HARTZELL PROPELLER INC.
SERVICE BULLETIN
TRANSMITTAL SHEET
HC-SB-61-392

108298 Cylinder Bushing and 108346 Hub Bushing

February 23, 2022

This page transmits a revision to Service Bulletin HC-SB-61-392.

**108298 Cylinder Bushing
Figure 1**

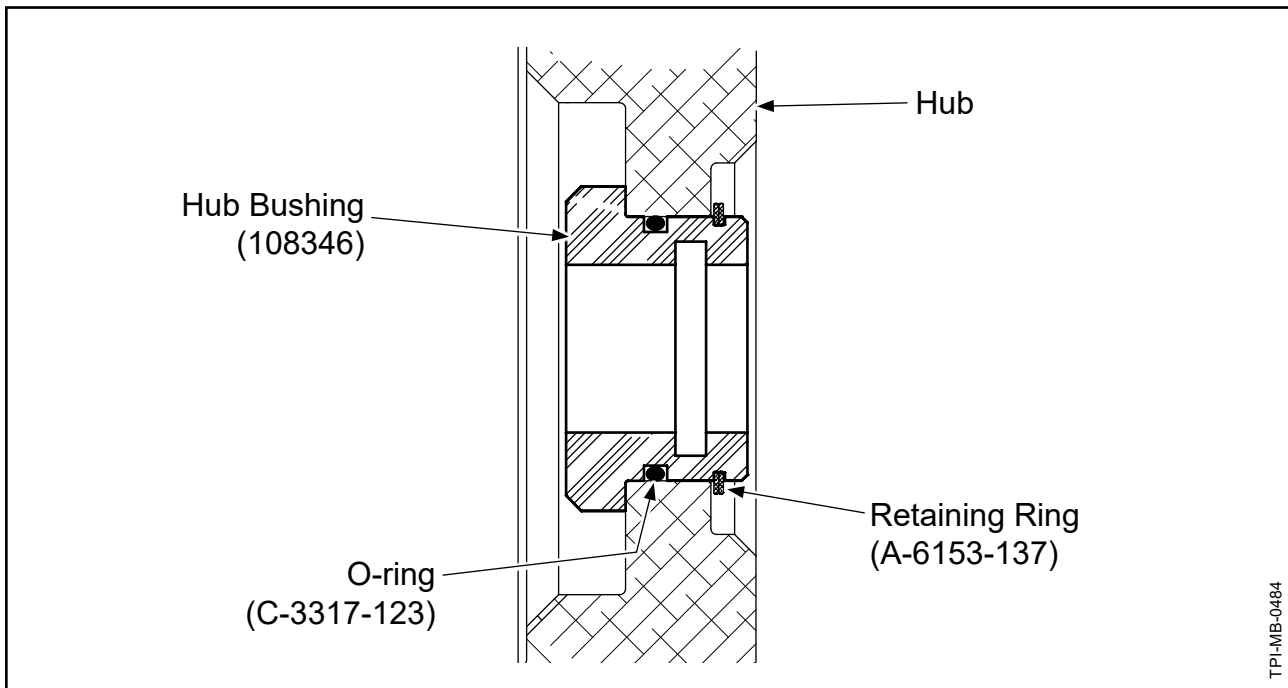
- (1) Hartzell Propeller Inc. has received reports of oil leaking at the A-3784 cylinder bushing on affected propellers.
 - (a) Hartzell is introducing the 108298 cylinder bushing as a replacement for the A-3784 cylinder bushing on affected propellers.
 - 1 The 108298 cylinder bushing has a machined O-ring groove on the OD of the bushing. This provides a more consistent seal between the bushing and the cylinder to prevent oil leaks. Refer to Figure 1.

Cylinder Inspection: Surface "J"
Figure 3

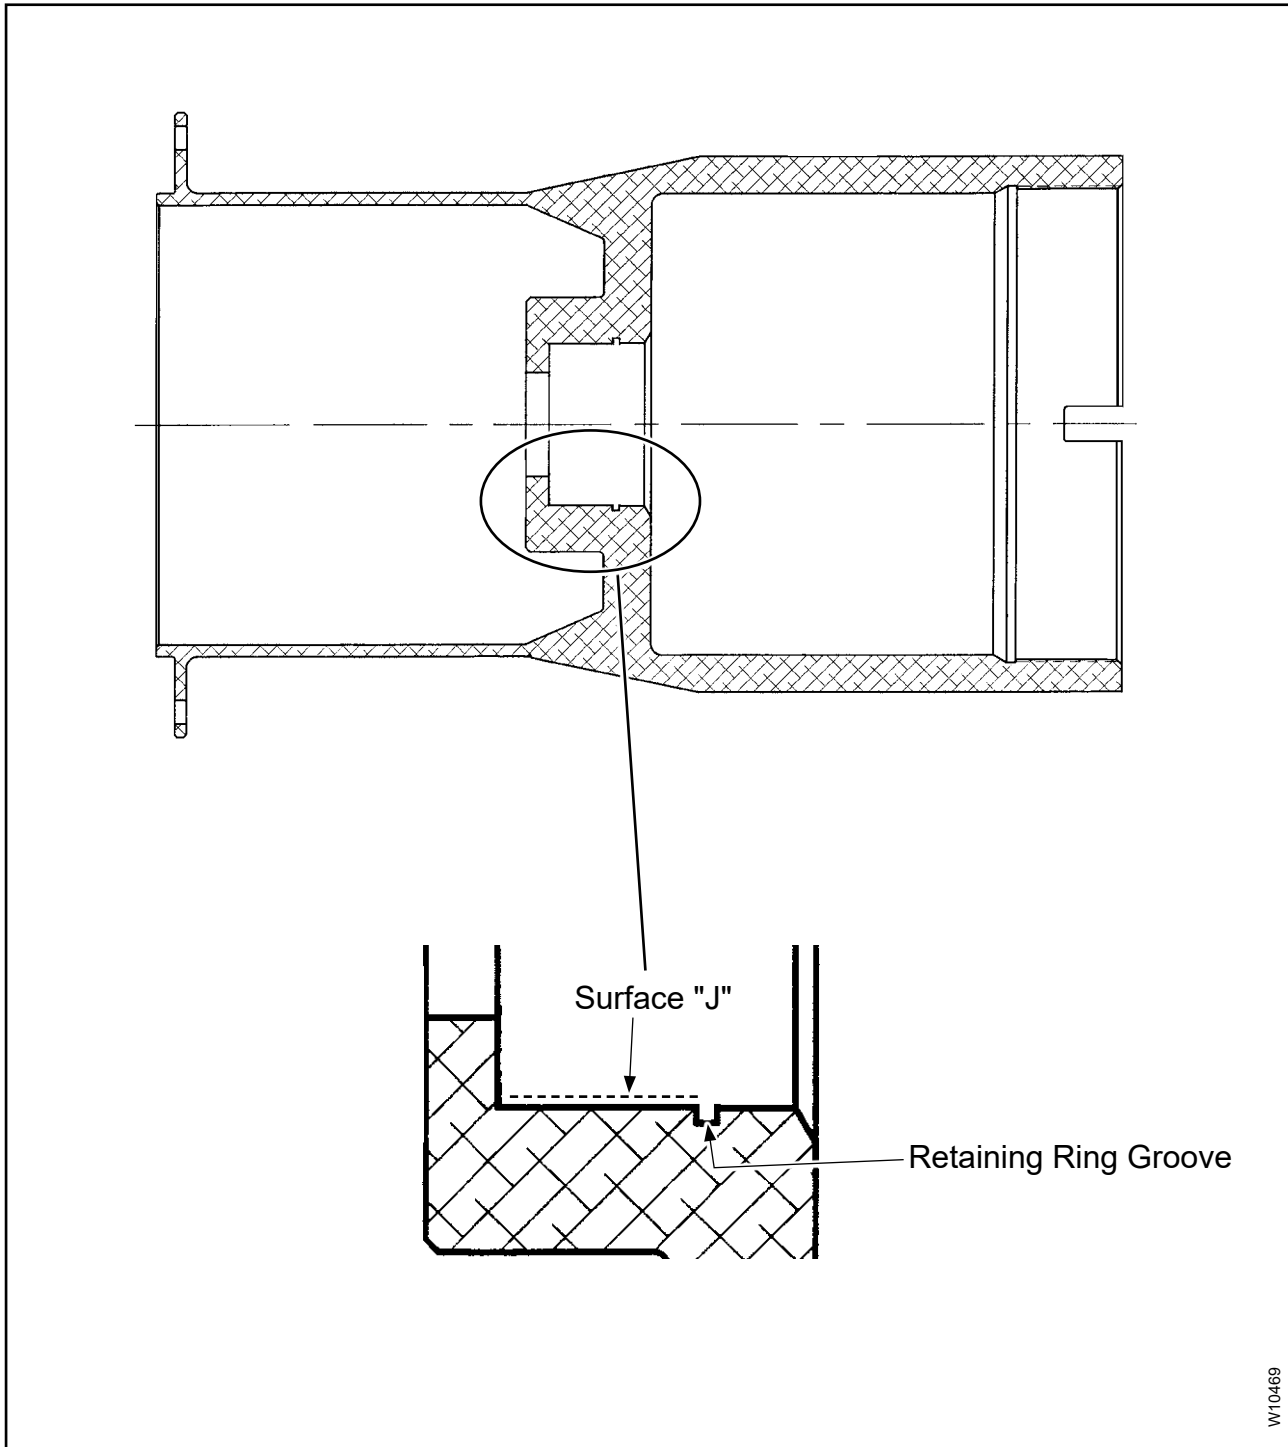
- (1) Inspect the cylinder in the affected propeller in accordance with the Check chapter of the applicable Hartzell Propeller Inc. overhaul manual, **except:**
 - (a) Inspect Surface "J" of the cylinder in accordance with Table 1 and Figure 3 in this Service Bulletin.

Inspect	Serviceable Limits	Corrective Action
<u>CYLINDER (Surface "J")</u> (Refer to Figure 3)		
(1) Using a Profilometer TE436-2 or equivalent, examine the finish on Surface "J".	The maximum permitted surface finish is 32Ra.	If the surface finish is greater than the permitted serviceable limits, polish Surface "J" using 3M microfinishing film (373L), or equivalent. The maximum permitted diameter of Surface "J" after repair is 1.7560 inch (44.602 mm).

**108298 Cylinder Bushing Inspection
Figure 4**

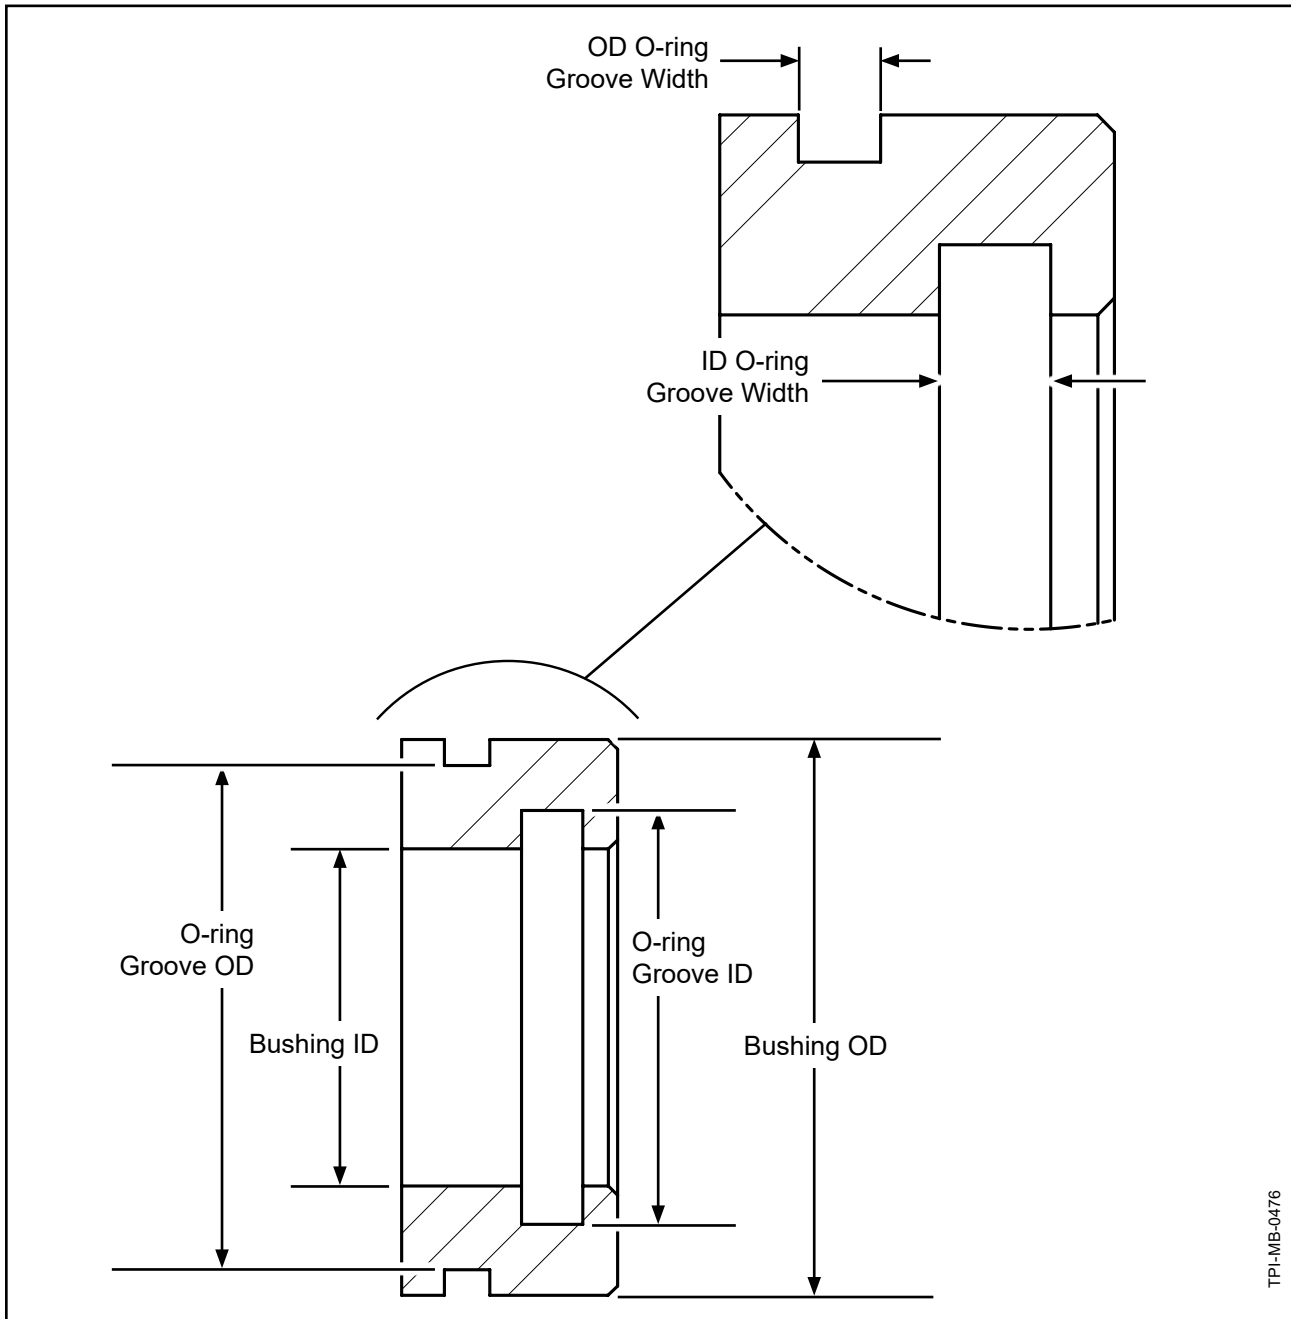
- (1) Inspect the 108298 cylinder bushing in accordance with Table 2 and Figure 4 in this Service Bulletin.

Inspect	Serviceable Limits	Corrective Action
<u>108298 CYLINDER BUSHING</u>		
(Refer to Figure 4)		
(1) Visually examine both sides of the cylinder bushing for wear, damage, and distortion.	Wear, damage, or distortion is not permitted.	If there is wear, damage, or distortion, replace the cylinder bushing.

(2) Measure the cylinder bushing OD.	The minimum permitted bushing OD is 1.750 inches (44.45 mm).	If the bushing OD is less than the permitted serviceable limit, replace the cylinder bushing.

(3) Measure the cylinder bushing ID and examine the surface finish.	The maximum permitted ID is 1.064 inches (27.02 mm). A smooth surface is required.	If the bushing ID is greater than the permitted serviceable limit, or if the surface finish is not smooth, replace the cylinder bushing.

(4) Measure the cylinder bushing O-ring groove ID and examine the surface finish.	The maximum permitted O-ring groove ID is 1.306 inches (33.17 mm). A smooth surface is required.	If the O-ring groove ID is greater than the permitted serviceable limit, or if the surface finish is not smooth, replace the cylinder bushing.

(5) Measure the cylinder bushing O-ring groove OD and examine the surface finish.	The minimum permitted O-ring groove OD is 1.586 inches (40.29 mm). A smooth surface is required.	If the O-ring groove OD is less than the permitted serviceable limit, or if the surface finish is not smooth, replace the cylinder bushing.

(6) Measure the width of the ID O-ring groove and examine the groove for wear, damage, and distortion.	The maximum permitted width of the ID O-ring groove is 0.170 inch (4.31 mm). Wear, damage, or distortion is not permitted.	If the width of the ID O-ring groove is greater than the permitted serviceable limit, or if there is wear, damage, or distortion, replace the the cylinder bushing.

(7) Measure the width of the OD O-ring groove and examine the groove for wear, damage, and distortion.	The maximum permitted width of the OD O-ring groove is 0.146 inch (3.70 mm). Wear, damage, or distortion is not permitted.	If the width of the OD O-ring groove is greater than the permitted serviceable limit, or if there is wear, damage, or distortion, replace the the cylinder bushing.

Cylinder Leak Check Procedure
Figure 6

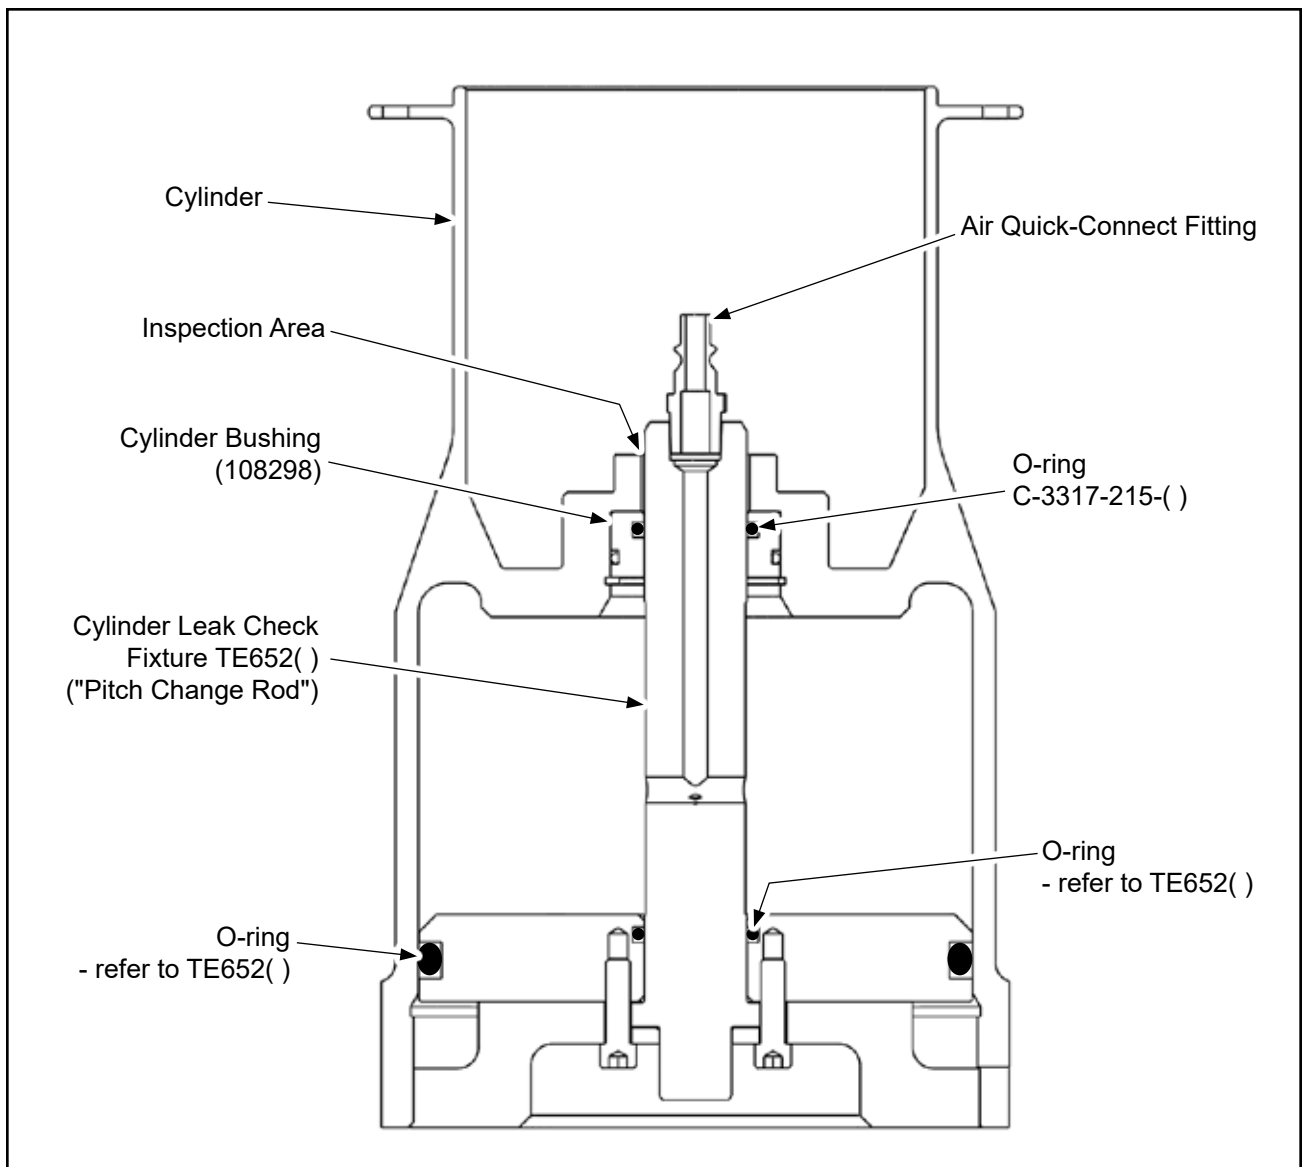
D. Cylinder Leak Check Procedure (Refer to Figure 6)

- (3) Install the cylinder leak check fixture TE652() from the threaded end of the cylinder as shown in Figure 6.

- (6) Check for leaks in the inspection area identified in Figure 6.

Inspection: 108346 Hub Bushing
Figure 7

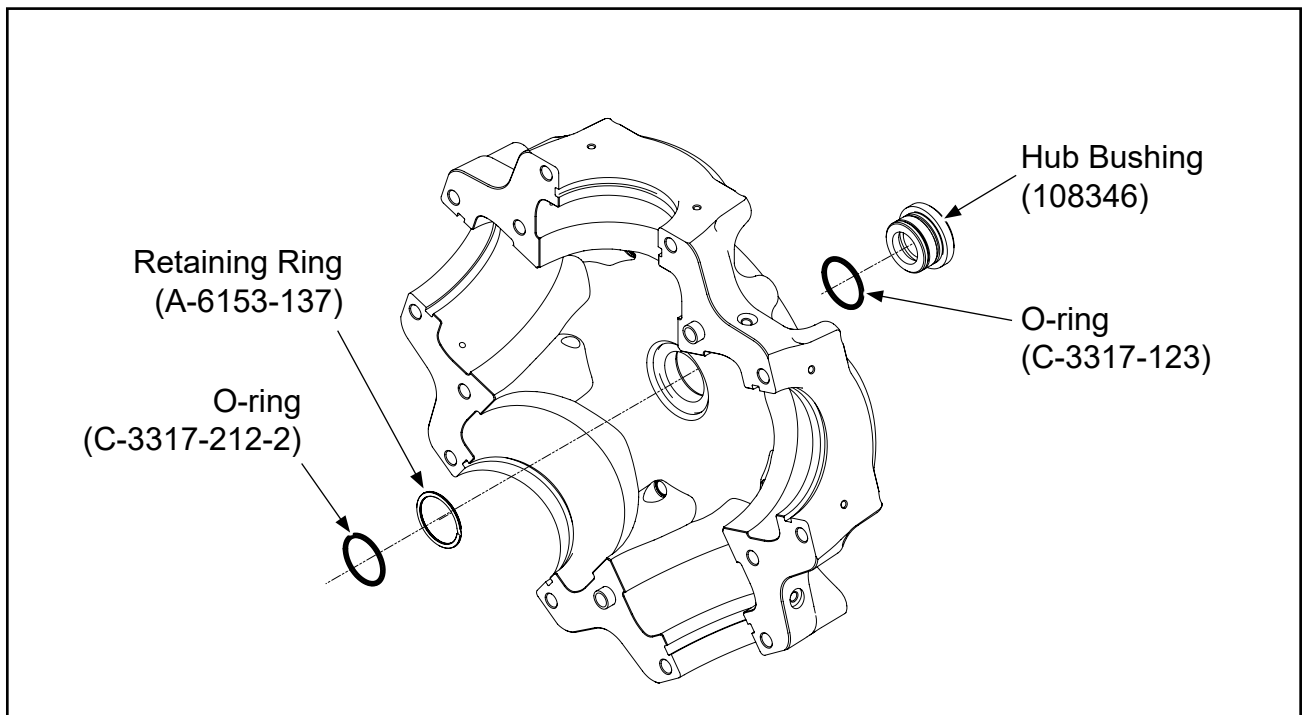
Inspect	Serviceable Limits	Corrective Action
<u>108346 Hub Bushing</u> (Refer to Figure 7)		
(1) Measure the ID of the hub bushing ("A").	The maximum permitted ID is 0.878 inch (22.30 mm). A smooth surface finish is required.	If the ID is greater than the permitted serviceable limits or the surface finish is not smooth, replace the hub bushing.

(2) Measure the ID of the hub bushing O-ring groove ("B").	The maximum permitted ID is 1.121 inches (28.47 mm). A smooth surface finish is required.	If the ID is greater than the permitted serviceable limits or the surface finish is not smooth, replace the hub bushing.

(3) Measure the OD of the hub bushing O-ring groove ("C").	The minimum permitted OD is 1.211 inches (30.76 mm).	If the OD is less than the permitted serviceable limits, replace the hub bushing.

(4) Measure the OD of the hub bushing at two locations ("D1") and ("D2").	The minimum permitted OD at each location is 1.373 inches (34.88 mm).	If the OD is less than the permitted serviceable limits, replace the hub bushing.

(5) Measure the OD of the hub bushing at location ("D3").	The minimum permitted OD is 1.368 inches (34.75 mm).	If the OD is less than the permitted serviceable limits, replace the hub bushing.

(6) Measure the OD of the retaining ring groove ("E").	The minimum permitted OD is 1.284 inches (32.62 mm).	If the OD is less than the permitted serviceable limits, replace the hub bushing.

(7) Visually examine each shoulder of the retaining ring groove for damage.	The maximum permitted total accumulated damage for each shoulder is 25% of the circumference.	If the damage for either shoulder is greater than the permitted serviceable limits, replace the hub bushing.

(8) Measure the width of the retaining ring groove ("F").	The maximum permitted width is 0.062 inch (1.57 mm).	If the width is greater than the permitted serviceable limits, replace the hub bushing.

108346 Hub Bushing Installation
Figure 8

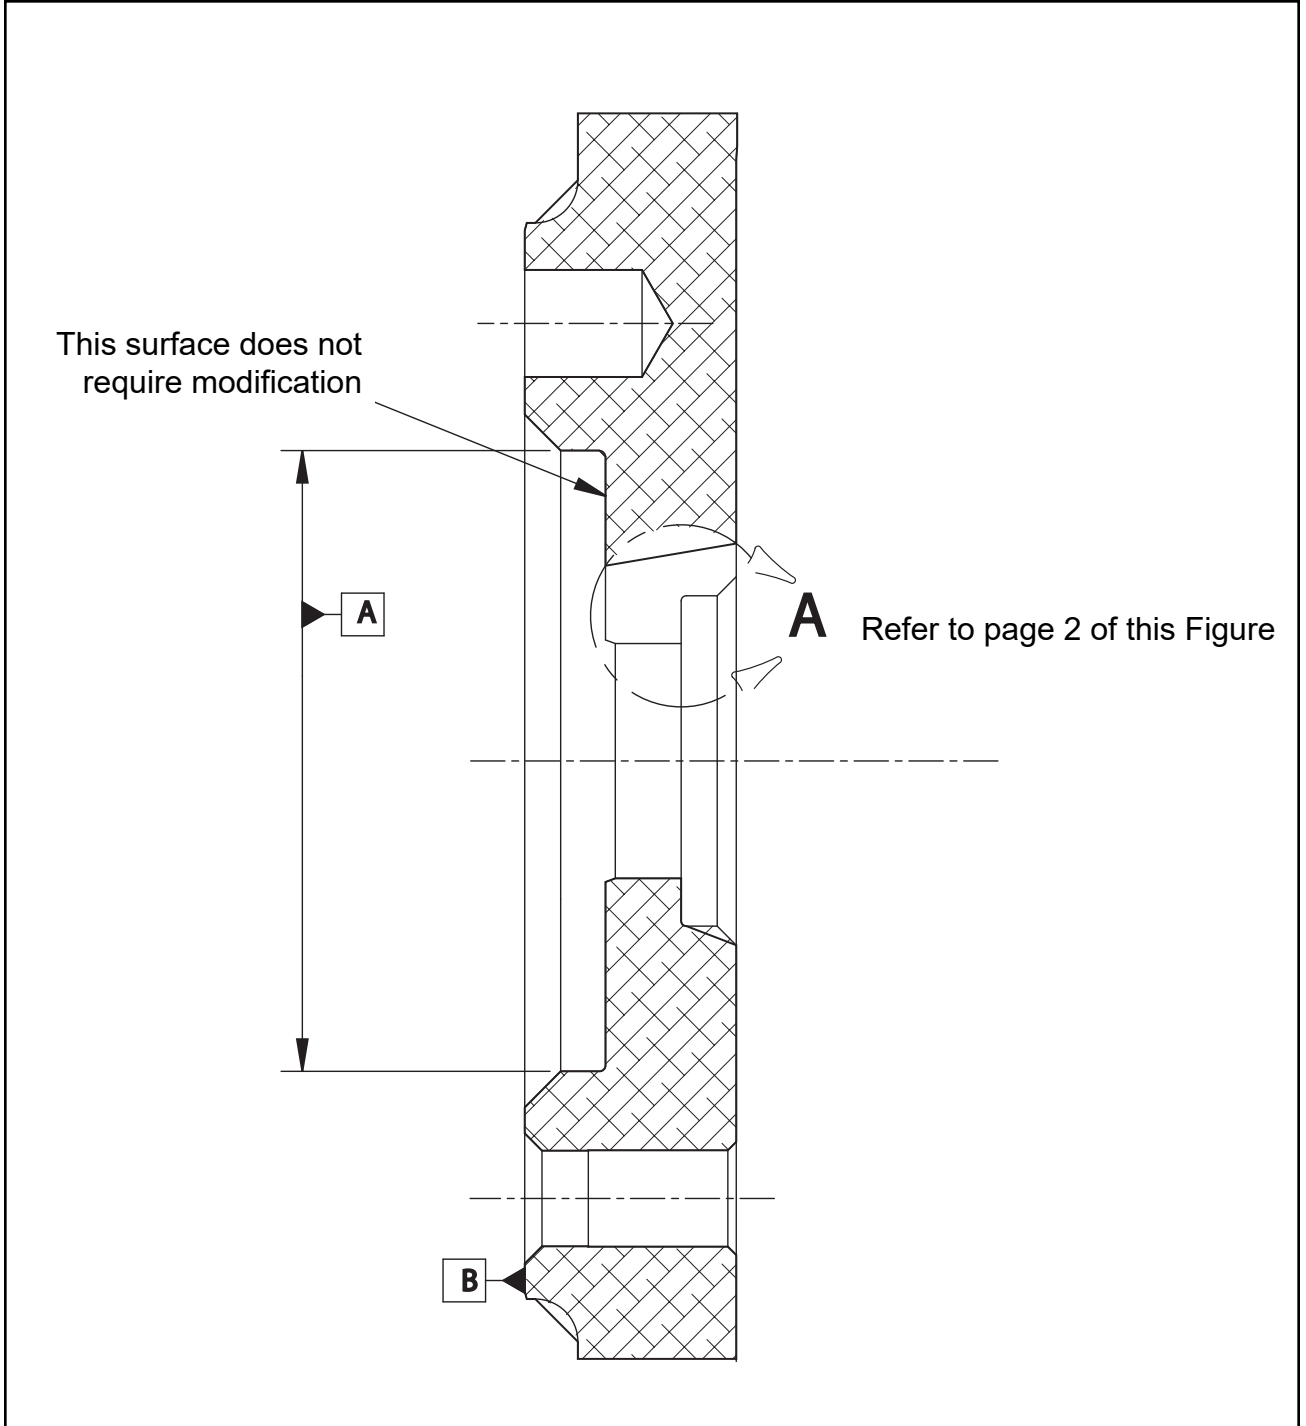
- (1) Remove/disassemble the propeller in accordance with the Disassembly chapter in the applicable Hartzell Propeller Inc. overhaul manual, **except:**
 - (a) Remove and discard the 104903 hub bushing.
- (2) Install the hub bushing (108346) and O-ring (C-3317-123) in accordance with Figure 8 and the following steps:
 - (a) Using a clean cloth dampened with MEK CM106, clean the OD of the 108346 hub bushing and the bore in the engine-side half of the hub.
 - (b) Install the O-ring (C-3317-123) in the groove on the OD of the hub bushing (108346).
 - (c) Install the hub bushing (108346) in the bore of the engine-side hub half.

- (d) Install the retaining ring (A-6153-137) in the groove on the hub bushing (108346).
- (e) Install the O-ring (C-3317-212-2) in the groove on the ID of the hub bushing (108346).
- (3) Perform a leak inspection of the hub in accordance with the Aluminum Hub Overhaul chapter of Hartzell Propeller Inc. Standard Practices Manual 202A (61-01-02).
